## INTEROFFICE CORRESPONDENCE

DATE: January 7, 1994 *bef*  
TO: N. M. Hutchins, ES&E, Bldg. 080, X8579  
FROM: S. R. Keith, Solar Pond Projects, Bldg. 080, X8541 *SRK*  
SUBJECT: PATS ITEM 285 "IDEARS" ITEMS #148 AND #149 - SRK-005-94

## RESPONSE/ACTION PLAN

RFO ERD EGG 93 0148: Utilize Building 374 for processing of Modular Storage Tank (MST) water and excess Solar pond water, in preference to Building 910.

# FLOW DIAGRAM

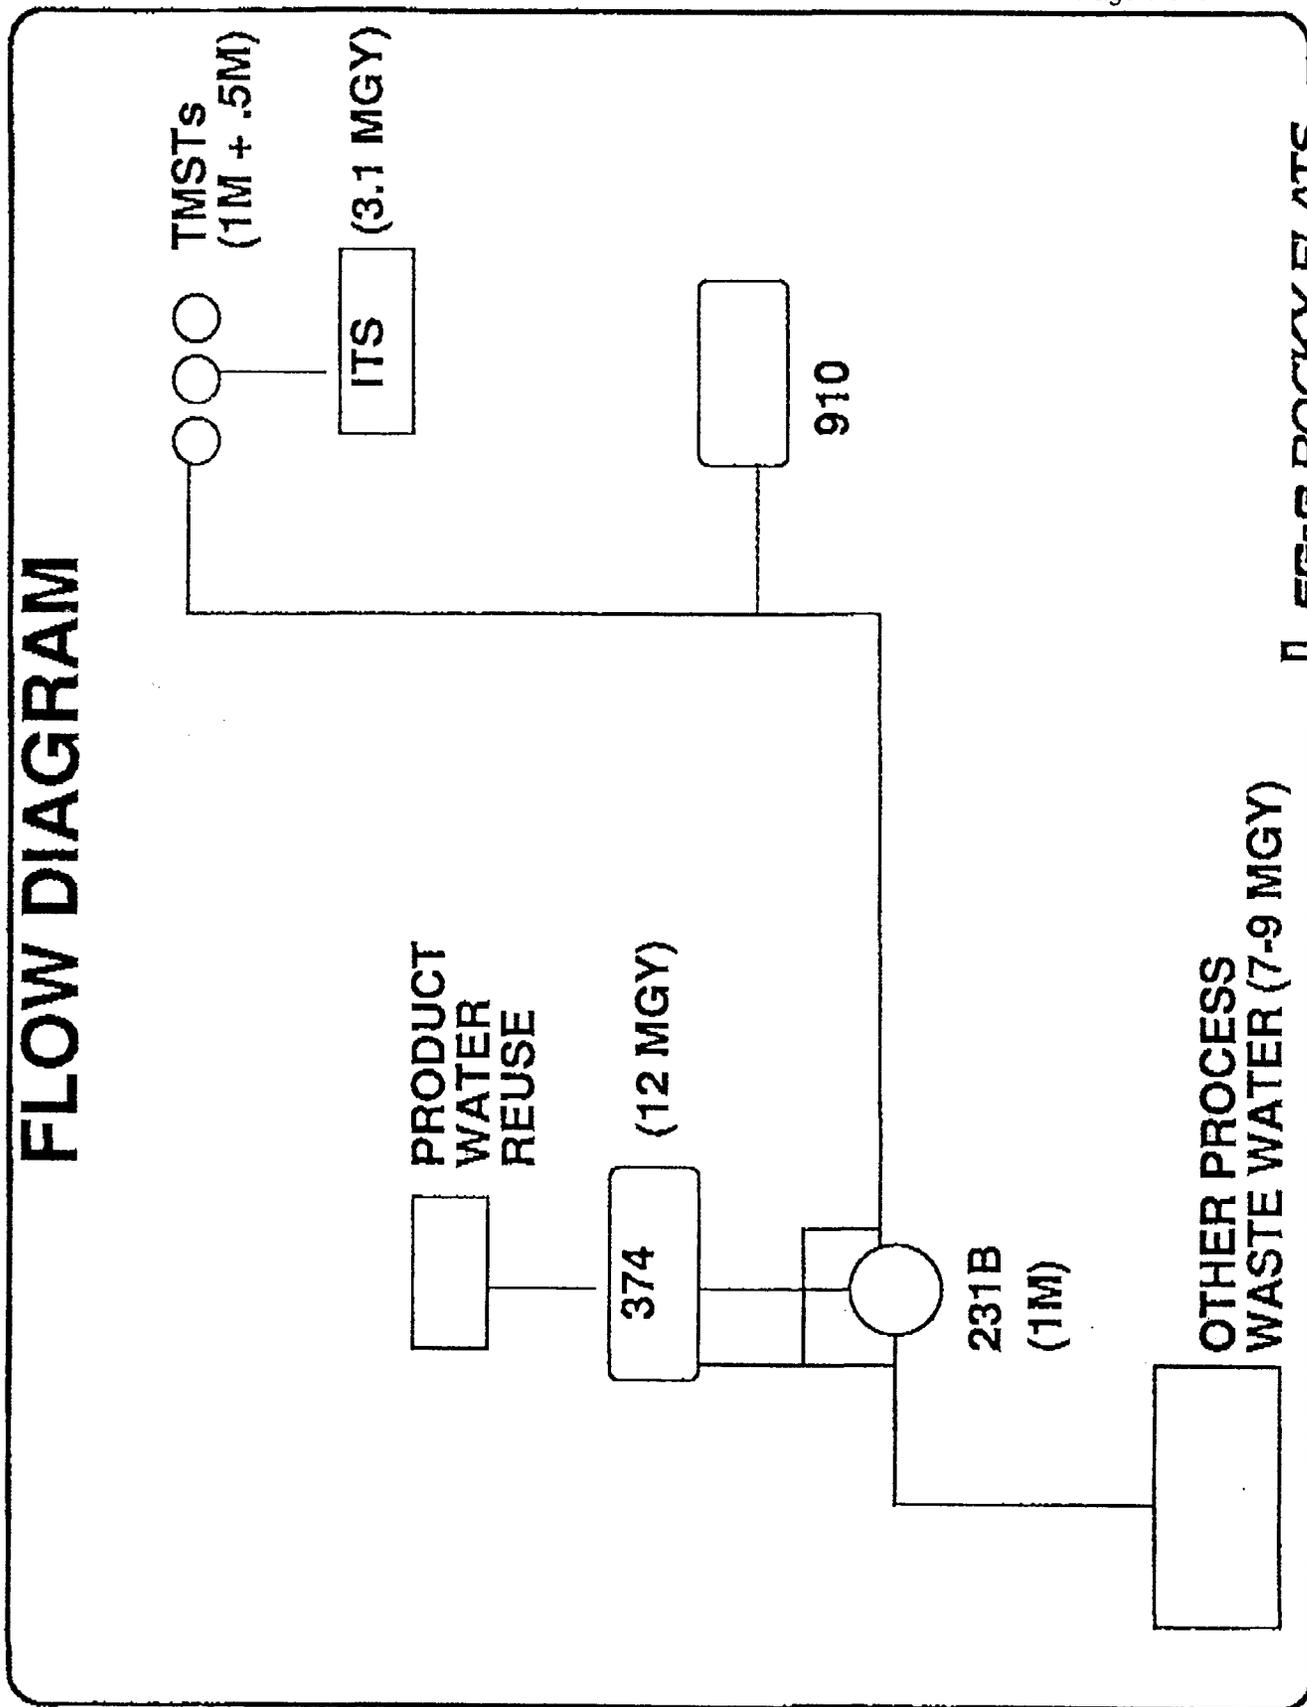
The Solar Ponds Remediation Program Office should investigate options and the necessity of installing the capability to pump water from the modular tanks to Building 374. There already exists a double contained, above ground transfer line that is currently being used to pump 207-B North water into the valve vault system and ultimately to Building 374. It would be a relatively simple design change to allow the modular tanks to be pumped into this line.
